GRANDVIEW RESERVE PHASE 2 EARLY GRADING AND EROSION CONTROL PLAN

LAND USE REVIEW FILE NO: PUDSP-23-006

EARLY GRADING & EROSION CONTROL PLANS

COVER

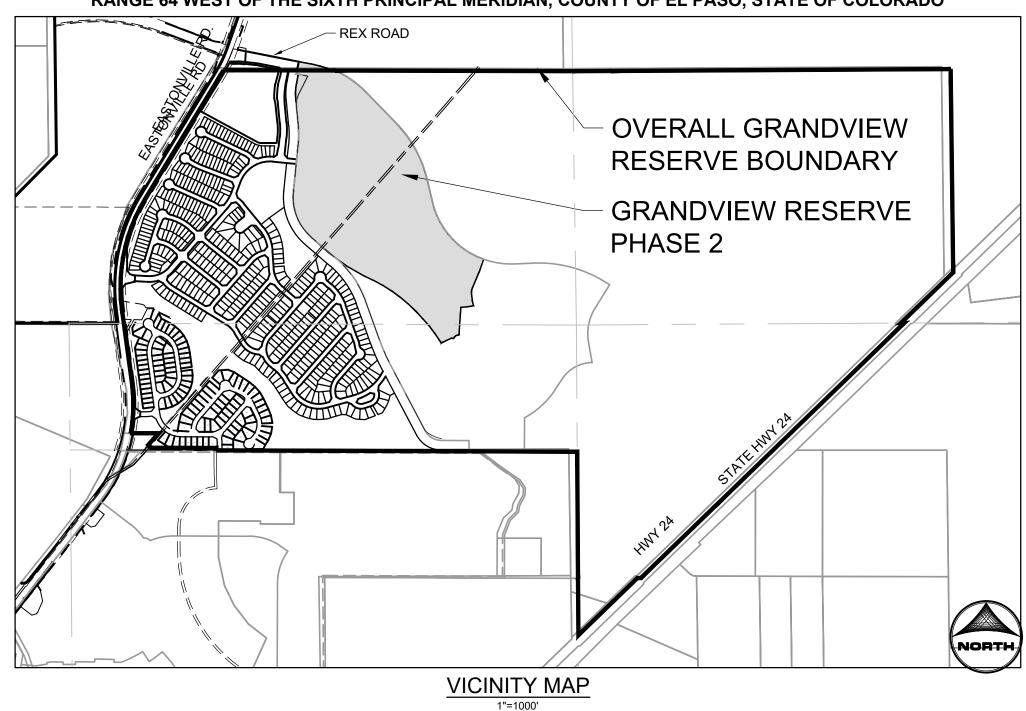
Inresolved, could not find the note: Due to the project being within the Upper Black irrel Drainage Basin, please add the following note

he Upper Black Squirrel Creek (UBSC) Groundwater Management District requires that ny groundwater discharged to the surface or into an underdrain system must be rated back into the ground. It is the developer's responsibility to comply with the
